MHS LAKE ROAD SPORTS COMPLEX

CITY OF MILWAUKIE
PLANNING DEPARTMENTMarch 2nd, 2018Brett Kolver
Associate Planner
6101 SE Johnson Creek Blvd.
Milwaukie, OR 97206**SUBJECT: #CSU-2018-001****SITE: MHS Lake Road Sports Complex (2905 SE Lake Rd)**

3J Consulting has reviewed the City's February 6, 2018 correspondence regarding our client's application for a modification to the Lake Road Sports Complex Community Service Use. Over the course of the last month, we have provided additional documentation in support of the application in our effort to address the issues raised within the City's request for additional information.

revisions	
phase date project	LAND USE 12.15.2017 17012
SITE PLAN PEDESTRIAN PATH PHOTOMETRICS	
E1

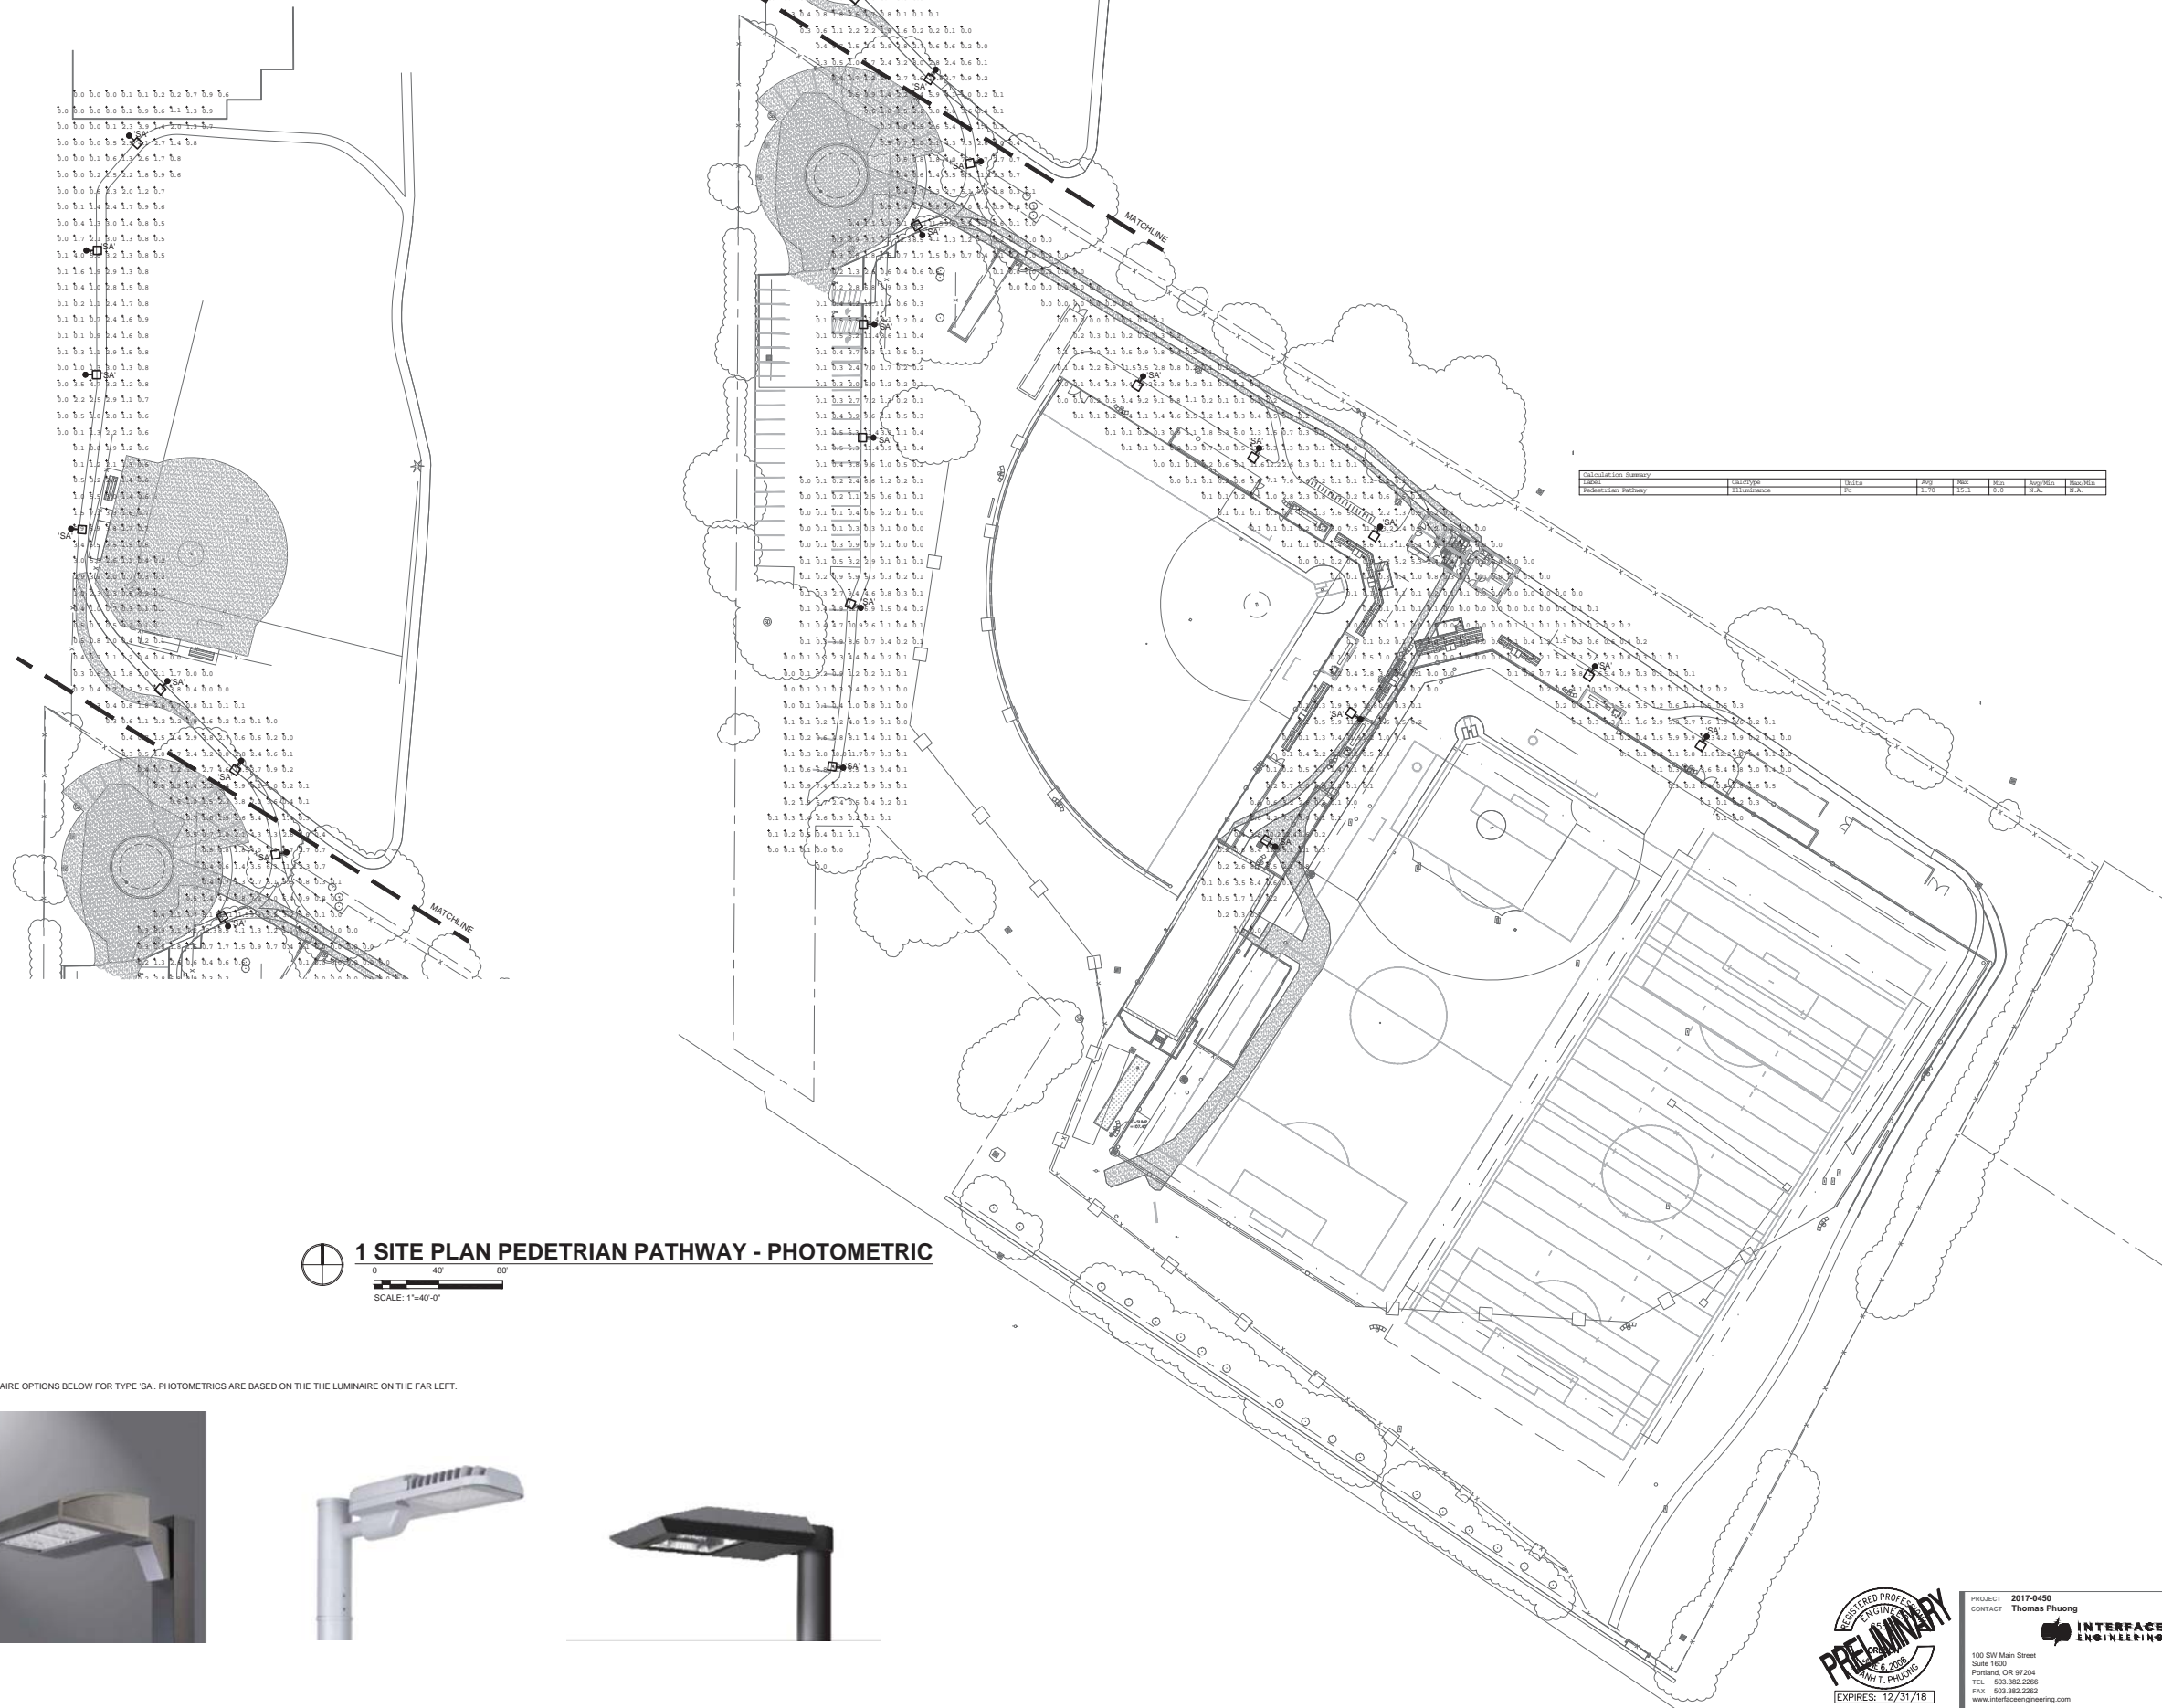
- (4) **Field lighting plan – The submitted plans only include general locations of the proposed field lights. Provide a field lighting plan, including photometric data sufficient to demonstrate minimum lighting levels and limited light spill across property boundaries. In addition, provide supplemental information regarding the proposed field light located in center field of the eastern baseball field and how soccer/football can occur in the eastern field.**

- b. The proposed pathway lighting information on Sheet E1 should be accompanied by a narrative description regarding the hours of use.

Applicant's Response: The Applicant has provided photometric plans for fields and pedestrian pathways (E1 and E2) that demonstrate minimum lighting levels and limited light spill across property boundaries. As shown, no field light is located in the center field of the eastern baseball field.

GRADING PLAN
MILWAUKIE HS FIELD IMPROVEMENTS
 MILWAUKIE, OREGON

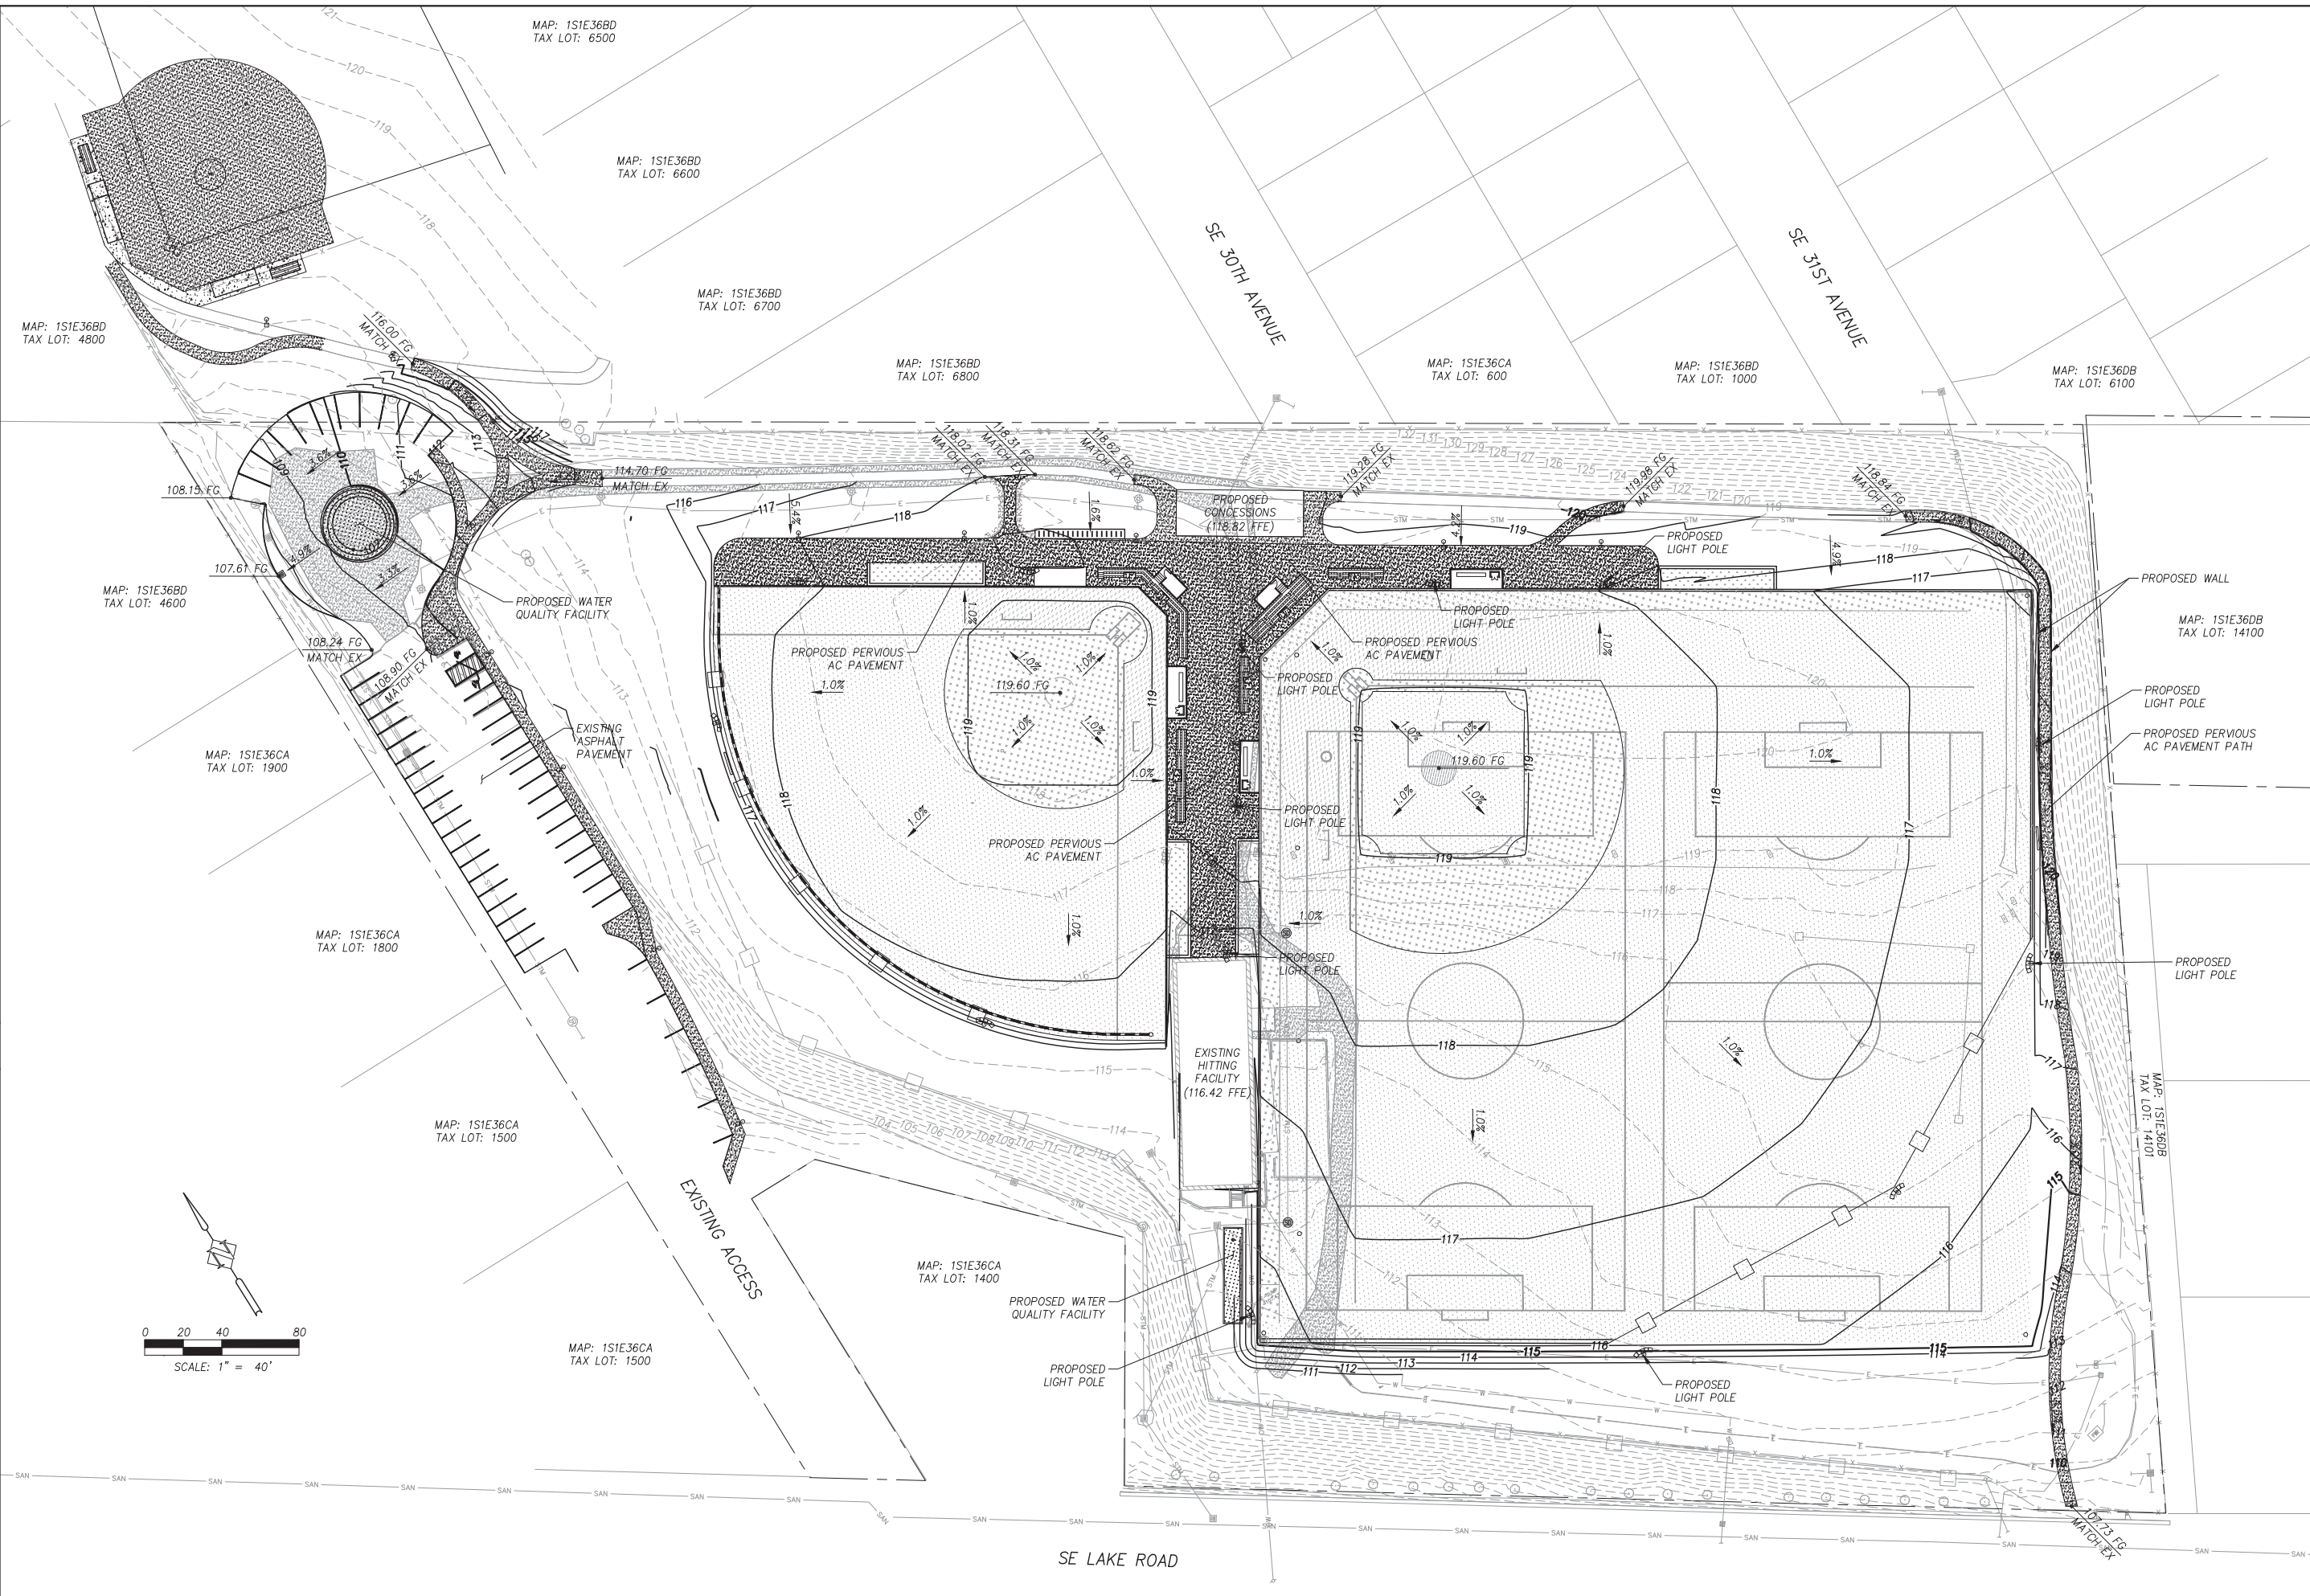
- (1) Detailed site plan –The plans should be amended to include setback dimensions for all existing and proposed structures.

The Applicant has provided updated site plans that include setback dimensions for all structures.
